DEVIATION REQUEST AND DECISION FORM

Project Name : Trails at Aspen Ridge Filing 1
Schedule No.(s) : 5500000412
Legal Description : Unplatted Land

A deviation from the standards of or in Section 3.3.1.J.2 of the Engineering Criteria Manual (ECM) is requested.

TRAILS AT ASPEN RIDGE			
FILING NO. 1 ROADWAY & STORM IMPROVEMENT PLANS			
STORM DRAIN PLAN & PROFILE			
DESIGNED BY:	KMZ	SCALE	DATE ISSUED: SEPTEMBER, 2019
DRAWN BY:	LCB	HORIZ 1" = 40'	DRAWING No. SD16
CHECKED BY:	NMS	VERT. 1" = 8'	SHEET 62 OF 73

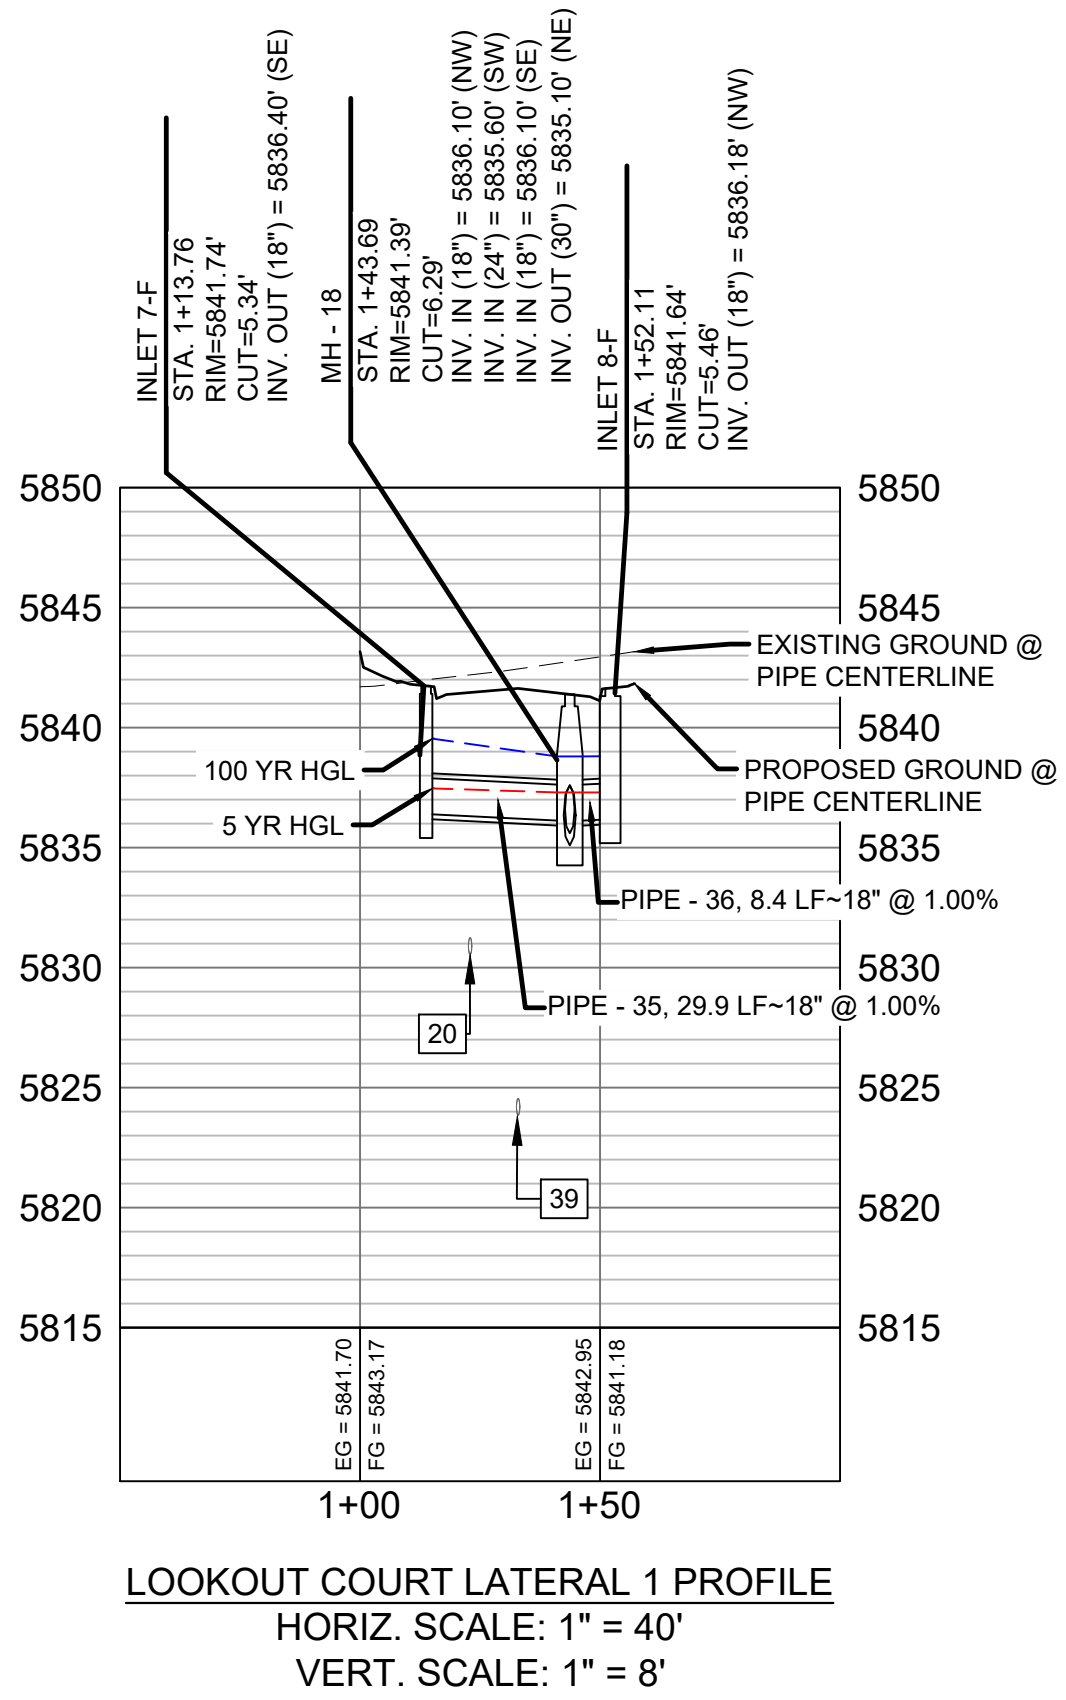
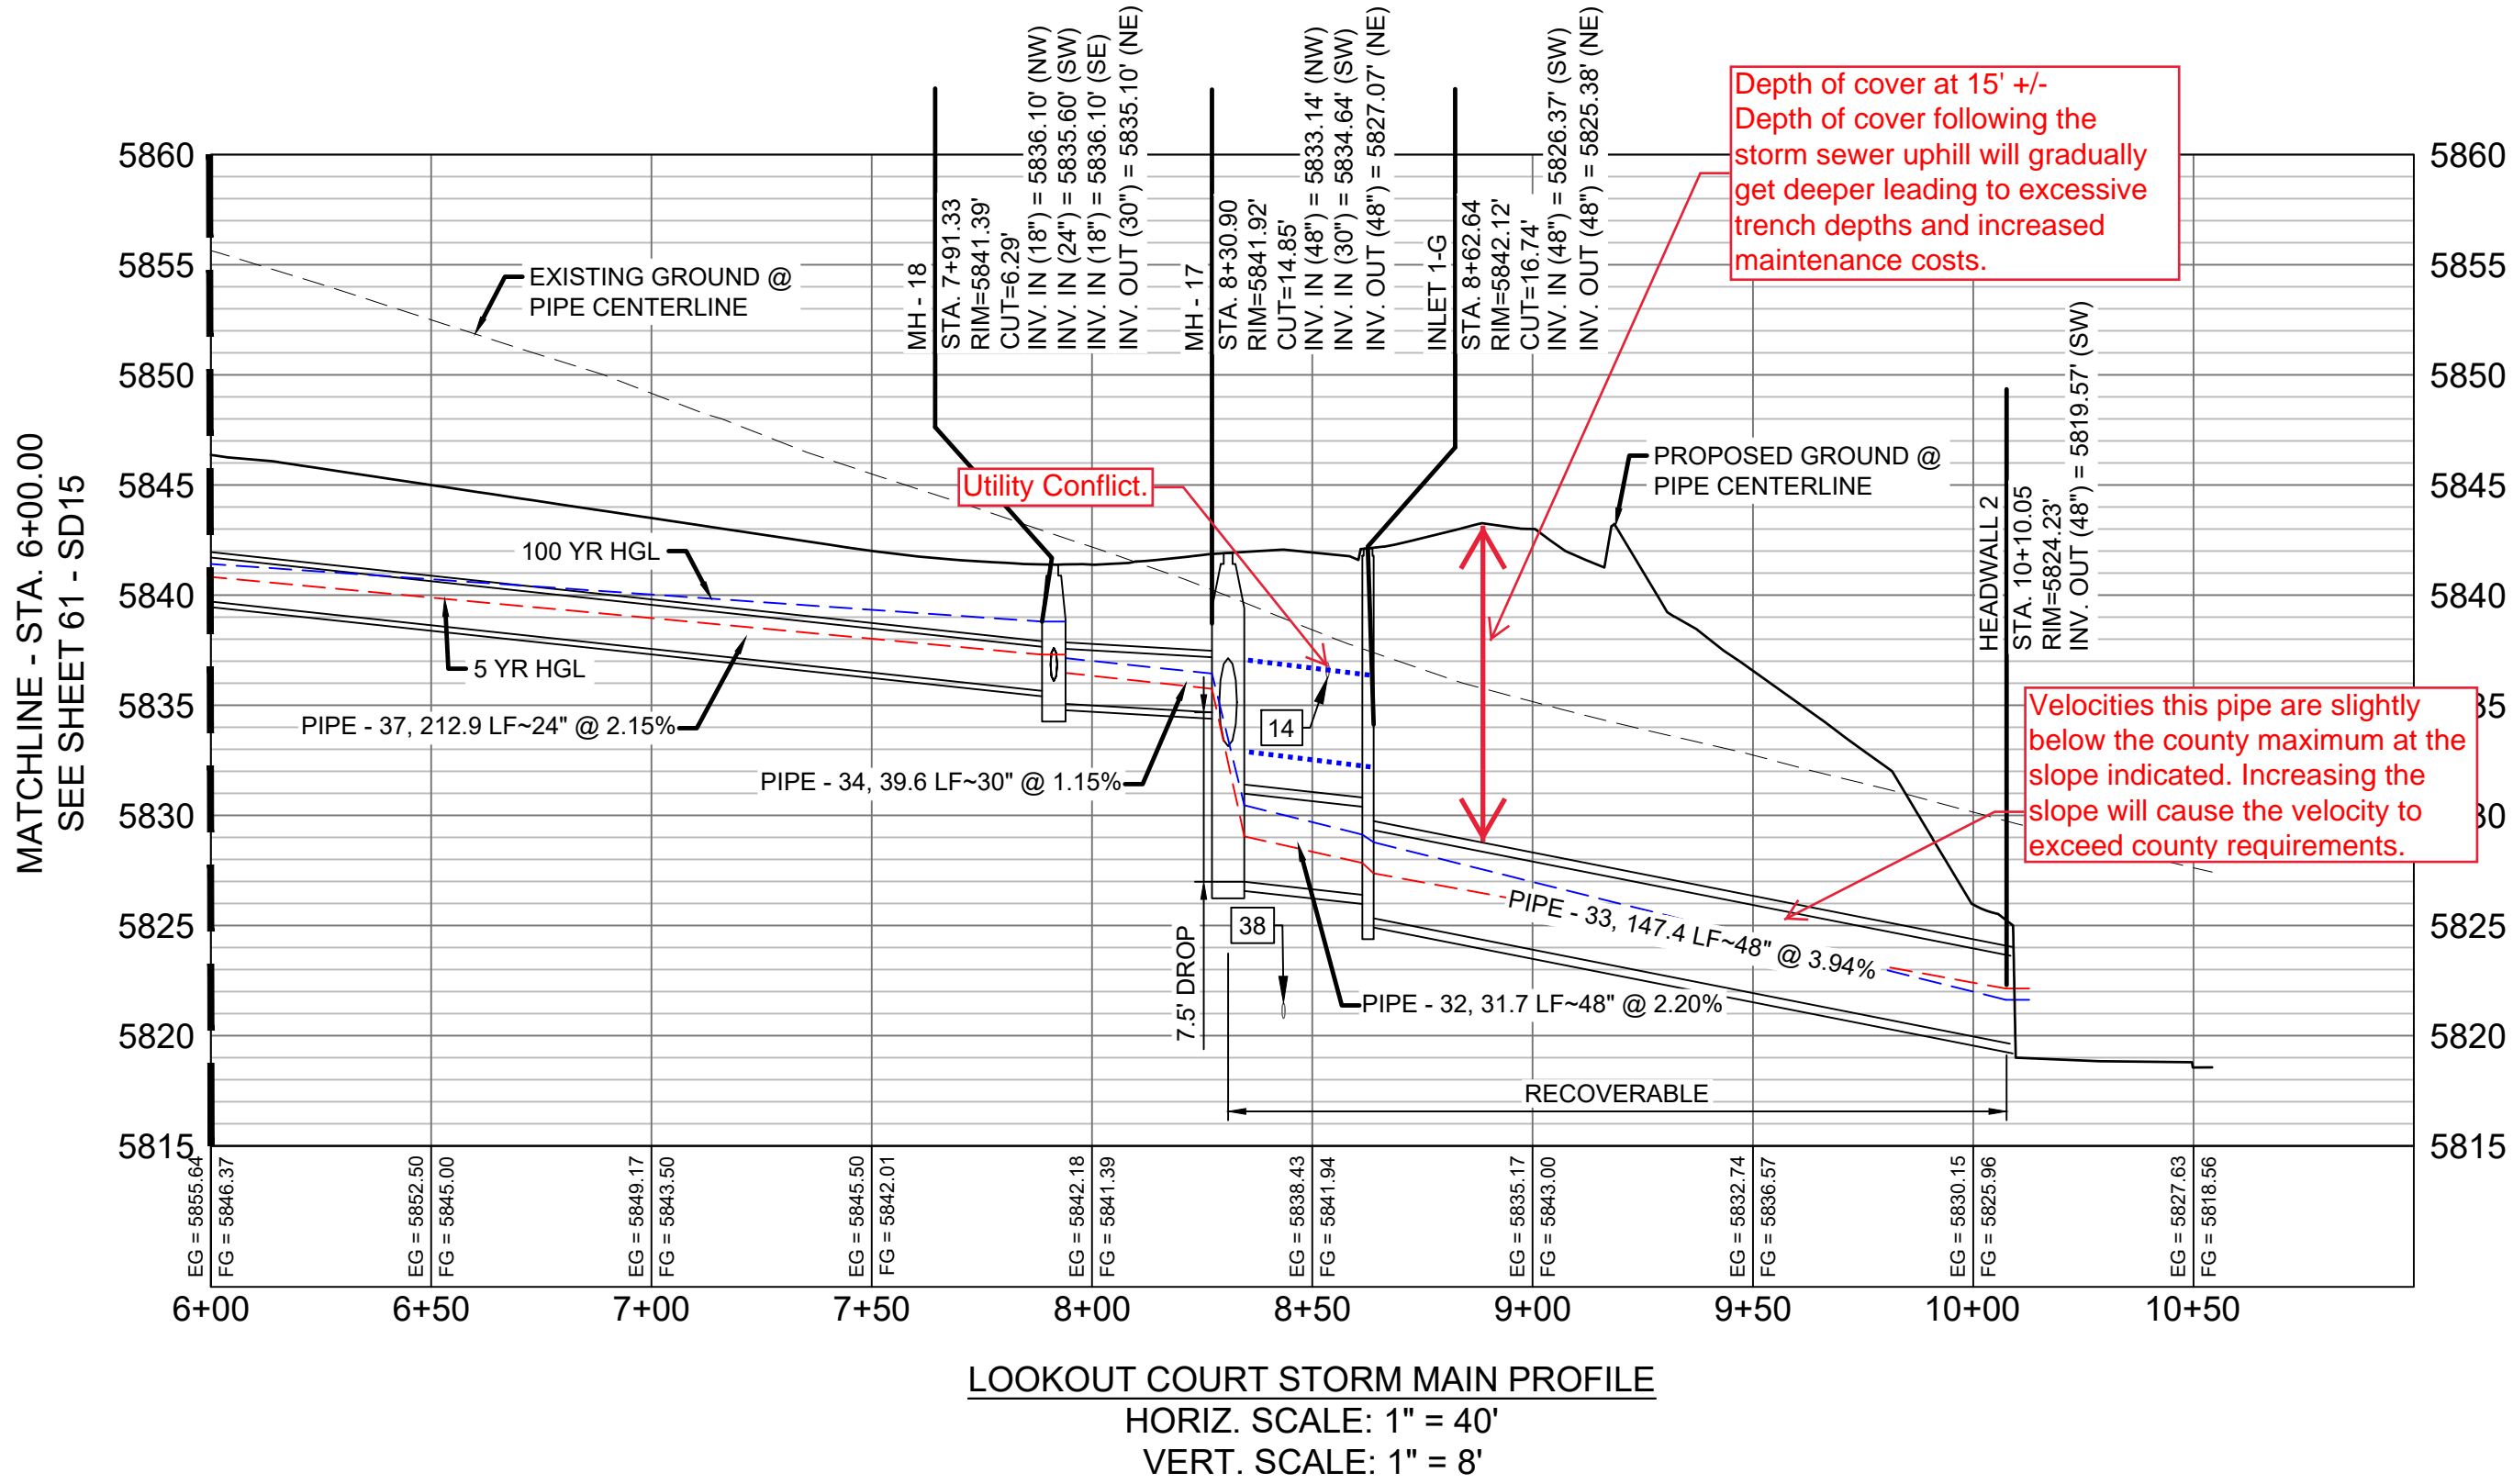
Please note that the storm sewer system has been optimized to be below the county water velocity requirement of 18 ft/s and minimize depth of cover. The drop manhole is a vital component of this design.
